UNITED STATES PATENT AND TRADEMARK OFFICE

APPLICATION NO.	FILING DATE	FIRST NAMED INVENTOR	ATTORNEY DOCKET NO.	CONFIRMATION NO.
10/657,375	09/08/2003	Werner Heierli	027262-182-D1	9448

Office Action Summary	Application No. 10/657,375	Applicant(s) HEIERLI, WERNER 	
	Examiner Chapman E Jeanette	Art Unit 3635

PATENT COPIES W/ANNOTATIONS

(10) **Patent No.: US 6,408,581 B2**
(45) **Date of Patent: *Jun. 25, 2002**

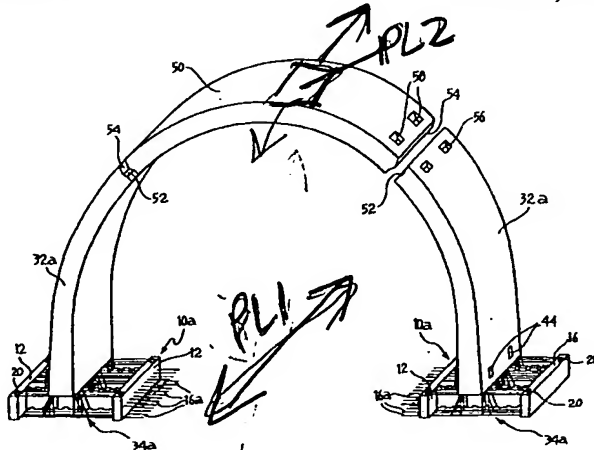
gc Claims 25, 37-39, 41, ^{46, 47}66 and 68 are rejected under 35 U.S.C. 102(b) as being anticipated by Monachino (6408581). Monachino et al discloses a method of forming a hybrid arched overfilled bridge comprising:

- Defining a first pathway PL1; see annotations on patent copy;
- Defining a second pathway PL2 spaced above the first: see annotations on patent copy;
- Providing a plurality of precise side elements 32a;
- Erecting the precise side elements in two rows along the first pathway to extend toward the second pathway PL2;
- Casting in place a crown sector element between the two precast side elements to extend from one side element to the other so that the crown sector with the two side elements form a bridge;
- Forming a structural connection or shrinkage joints between/ in the crown sector and the two side elements; see figure 11;
- Figure 11 shows the crown sector with beveled edges

- At some time in place the precast side elements were lifted and set in place in footings 34a;
- Casting in place one or more crown sector elements between two space apart rows of precast side elements such that the one or more crown sector elements connect at the two space apart rows of side elements to define a bridge over the first pathway;
- Multiple crown sector elements are cast in place and each crown sector element extends along the first pathway for a length that connects multiple precast side elements of each row.
